# New Primary School at Edmondson Park Modification 1

State Significant Development Modification Assessment  
(SSD 10224 MOD 1)

April 2022

Figure 4 | Architectural Plans – amendments (Source: Applicants amended Architectural package)

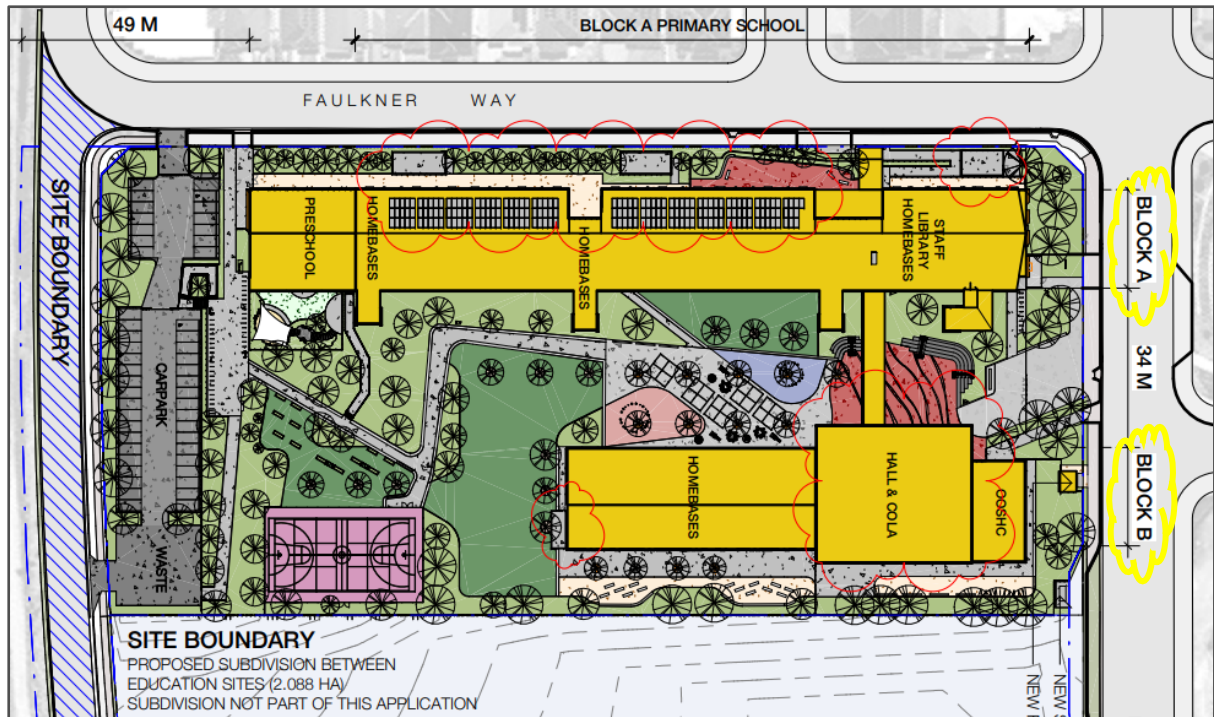
The modification application seek approval to amend condition A2, the stamped plans of SSD 10224, the proposed modification to the design includes:

- Relocating the approved solar panels from the roof of Block B (Hall and COLA building) to the roof of Block A.
- The addition of a roof access hatch to Block A to help servicing of the PV array.
- The addition of three mechanical enclosures along the Faulkner Way frontage. The enclosures will accommodate condenser units for the air-conditioning system.
- Modification of the landscape design along the Faulkner Way frontage to accommodate the proposed mechanical enclosures.
- The addition of a mechanical enclosure on the southern end of Block B.
- The addition of a small mechanical enclosure adjacent to the hall/out of school hours care on the south-eastern elevation of Block B.

The proposed amendments can be seen in Figure 4, which shows proposed location of all proposed amendments.

**Figure 8 |** Faulkner Way Mechanical Enclosures, Solar PV system and access hatch location (Source: Applicant’s Modification Report)

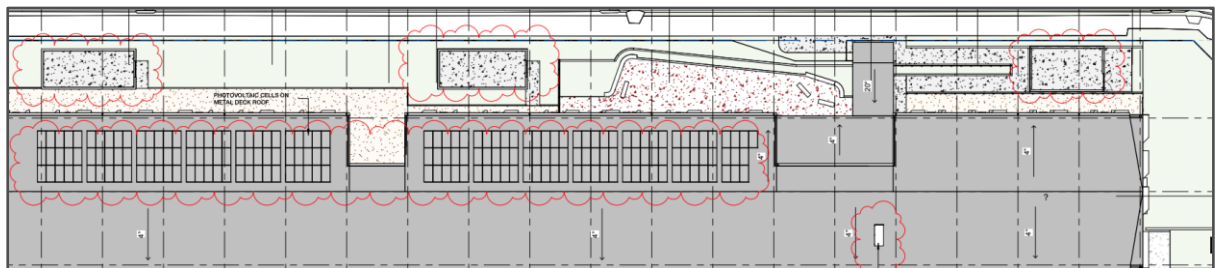
The modification also seeks to relocate solar PV system from Building B to Building A and add a roof access hatch at Building A which will provide essential access for the Solar PV system and other maintenance (Figure 8). The location of the solar PV system and access hatch will not be visible from the streetscape and therefore will not overshadow the site or surrounding properties. In line with the minor design changes outlined above, the listed architectural plans will be updated for consistency and to reflect the changes.

**Figure 9 |** mechanical enclosures (Source: Applicant’s Modification Report)

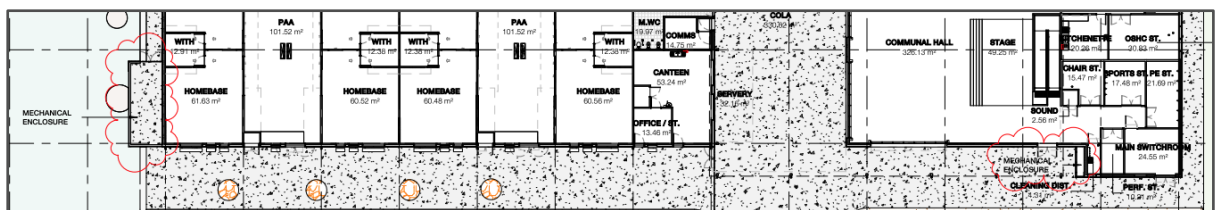
The mechanical enclosures along Faulkner Way are visible from the street, the applicant advises that the enclosures have been designed with the following design elements:

- Providing a minimum 750mm setback to separate the enclosures from the public domain
- Provision of landscaping within the 1050mm setback to establish a soft edge to the street and screen the enclosures

- Minimising the height of the enclosures to (1.8m), so that they predominantly sit below the height of the fence
- The northern enclosure (Figure 5) is set back behind the Buchan Avenue building line and is only 0.9m in height at street level. This arrangement will ensure that its visibility is minimised and it will not obstruct key sight lines in and around the secondary pedestrian entry on Faulkner Way, or vehicle sightlines at the intersection of Buchan Avenue and Faulkner Way.

The department considers the location, design and impact of the enclosures to be appropriate within the streetscape and will not significantly alter the architectural theme along Faulkner Way. No additional conditions of consent are required to manage the proposed modification, the requested changes to the stamped architectural and landscaping plans are appropriate in managing the change.

**Figure 10** | height of building – PV panel highlighted (Source: Proponent's Modification Report, 2022)

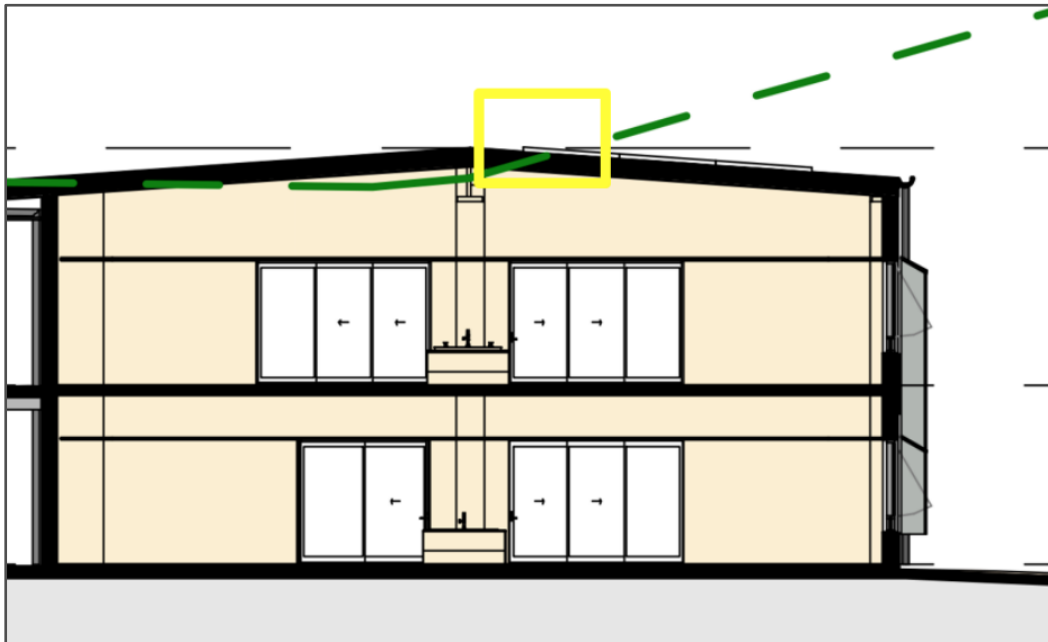
Council noted that the proposed relocation of the solar panels will result in a minor increase in the building height, Council does not oppose the minor increase commenting *'the breach is only limited to a small section of the panel which will not significantly contribute to the bulk and scale of the approved building'* and *'the proposed non-compliant height will not be readily visible from the public domain and will not result in any significant overshadowing to the adjoining properties'*.

The modification seeks to include solar panels on the western side of Building A which would result in a minor exceedance to the building height as shown in Figure 10. The difference to the approved height is the narrow width of a solar panel. It is noted that the minor height exceedance is supported by Council

Due to the minor nature of the height exceedance the Department supports the proposed changes as it will not alter the scale of the buildings as originally approved and will not result in any overshadowing or impact on the local streetscape. Whilst providing addition 20kw capacity and locating the solar panels at the tallest point of the subject site.
